CONTINENTAL MOTORS® AIRCRAFT ENGINE
CRITICAL SERVICE BULLETIN

CATEGORY 2
CSB05-8D

Supersedes CSB05-8C
TECHNICAL PORTIONS
FAA APPROVED

SUBJECT: Camshaft Gear (P/N 656818)

Figure 3. 1-3-5 Permold Crankcase Half, Boss Clearance Cut Repair

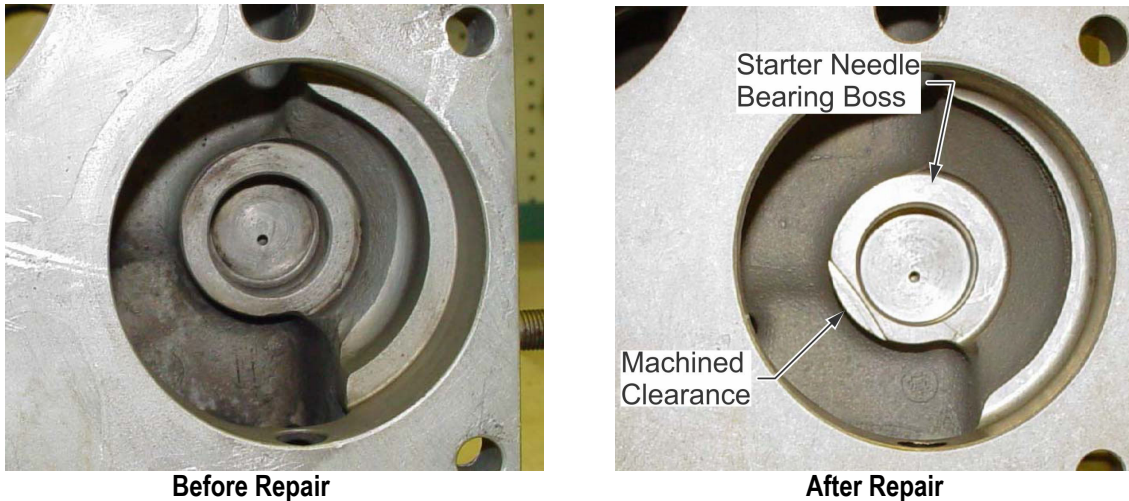
1. Inspect the needle bearing boss in the center of the starter adapter mounting pad. If a clearance cut (Figure 3) is present or if a clearance of 0.030" (or greater with the camshaft and gear installed) is provided under all conditions, the crankcase meets the clearance requirement.

2. If no clearance cut is present, or if, (with the camshaft and gear installed) the clearance is less than 0.030" under all conditions, the 1-3-5 crankcase half must be machined according to the following instructions by either:
 - a. sending the 1-3-5 crankcase half to be machined in accordance with instructions in section B. "Option 1, Permold Crankcase Repair, at Overhaul", *or by*
 - b. replacing the camshaft gear in Permold engines without splitting the crankcase (see C. "Option 2, Permold Crankcase Repair, in Service").

Figure 4. Radius Clearance Cut, Distance from Camshaft Bore Centerline, Permold Crankcase

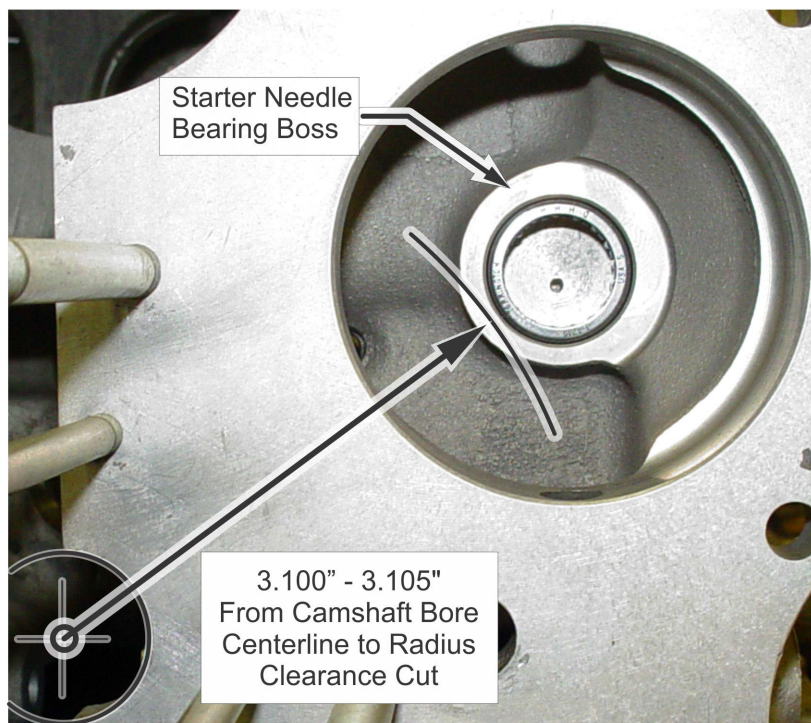
1. Measure and mark 3.100"- 3.105" from the camshaft bore centerline radius to the starter needle bearing boss (see Figure 4).
2. Cut a radius clearance cut in the outside edge of the starter drive needle bearing boss at a depth of 2.100 - 2.110" (see Figure 5) from the crankcase accessory mounting face.

Figure 20. Lower Rear Oil Gallery (Control) Plug, Sandcast 1-3-5 Crankcase Half

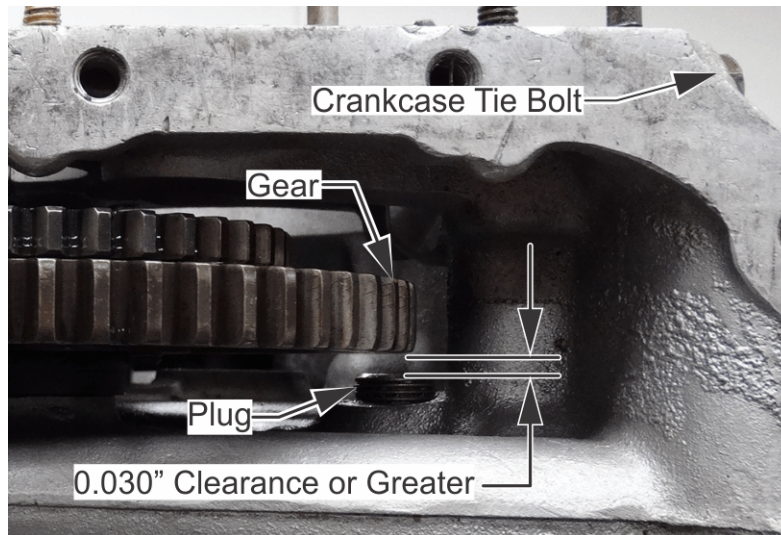
CAUTION: Camshaft gear (P/N 656818) is 0.060" wider at the circumference than the replaced camshaft gears (P/Ns 631845, 655430, 655516, or 656031). For engines with a Sandcast crankcase, the assembler must inspect and sustain a minimum clearance (0.030" or greater) between the camshaft gear (P/N 656818) and the oil gallery plug at the rear crankcase below the starter adapter (see step k. and Figure 20)).

- k. Measure the clearance between the oil gallery plug and the camshaft gear using a feeler gauge (see Figure 20). Ensure the minimum clearance is 0.030" or greater. If the clearance is less than 0.030":

- 1) Remove the safety wire and the rear crankcase tie bolt (P/N 627433) according to the instructions in the primary ICA (if it is blocking access to the oil gallery plug).

- 2) Remove the half-height alignment screw and remove the camshaft gear.
 - 3) Remove the oil gallery plug, clean the sealant residue from the crankcase and plug threads.

- 4) Install the oil gallery plug (according to the instructions in the primary ICA) to the maximum allowable torque specified in M-0, "Standard Practice Maintenance Manual, Appendix B" and verify required minimum clearance (0.030" or greater) is met.
